Contract # : 04-0120E4
Cty SF Rte 80 PM 13.4. 13.8
File # 31 .25 B**QUALITY ASSURANCE - NONCONFORMANCE REPORT**

Contract No. 04-0120E4
04-SF-80-13.4, 13.8
SAS T1 & E2 Foundations
SFOBB-ESSSP

Subject: NCR - Eaton Metal Products, 11/02/06 (CWR Performed Without Approval)

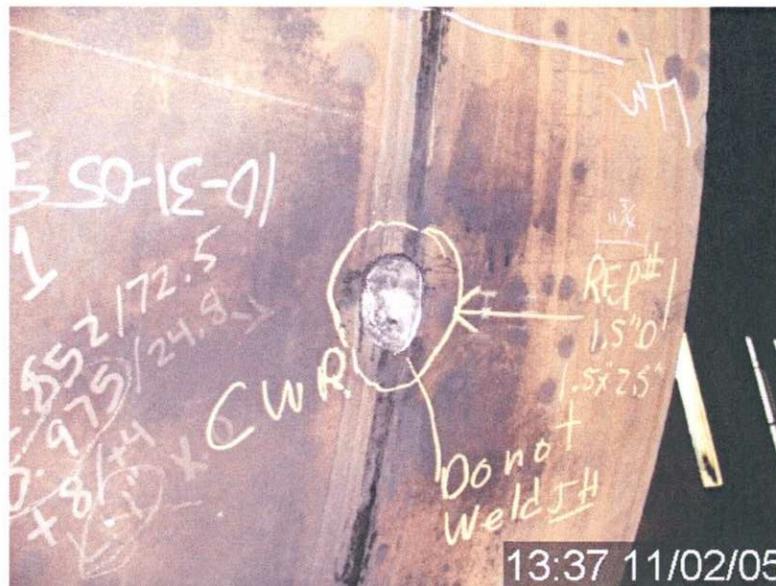
Description of Non-Conformance: Performing critical weld repair (CWR) excavation without approval of the Engineer. The critical weld repair location is on the outside diameter of girth seam weld (GS-4) of T1-3 Pile Sleeve, joining 90mm thick Mk#3 plate 15P to 50mm thick Mk#6 plate 72P. The depth of excavation is 43mm equal to approximately 85% of the 50mm weld thickness. See photo.

Contractor's proposal to correct the problem: Critical weld repair (CWR) excavation will not be welded prior submittal of CWR and engineers approval.

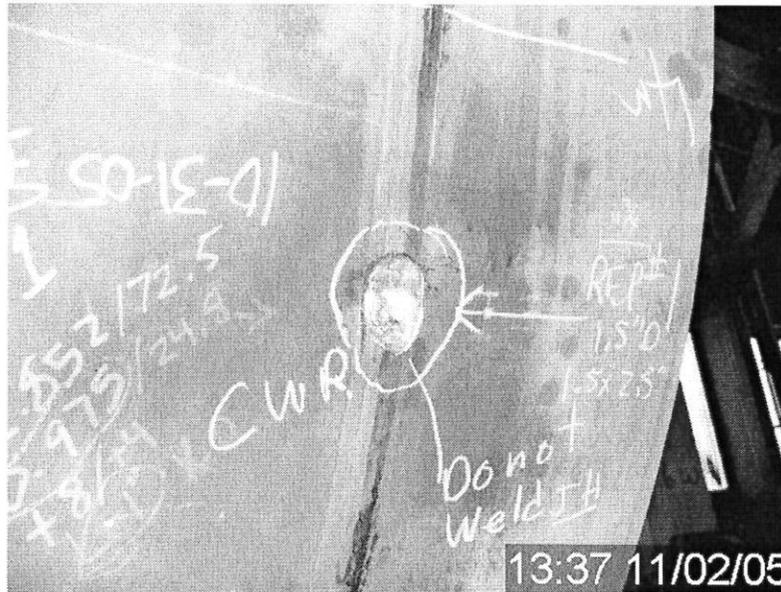
Description of Non-Conformance: Performing critical weld repair (CWR) excavation without approval of the Engineer. The critical weld repair location is on the outside diameter of girth seam weld (GS-4) of T1-3 Pile Sleeve, joining 90mm thick Mk#3 plate 15P to 50mm thick Mk#6 plate 72P. The depth of excavation is 43mm equal to approximately 85% of the 50mm weld thickness. See photo.

Contractor's proposal to correct the problem: Critical weld repair (CWR) excavation will not be welded prior submittal of CWR and engineers approval.

The clearing documents for this CWR were provided by KFM as Submittal No. 226, Revision No. 01, dated January 12, 2006, and were approved by the Department's Letter No. 717 dated January 19, 2006. The Department considers this NCR to be resolved.
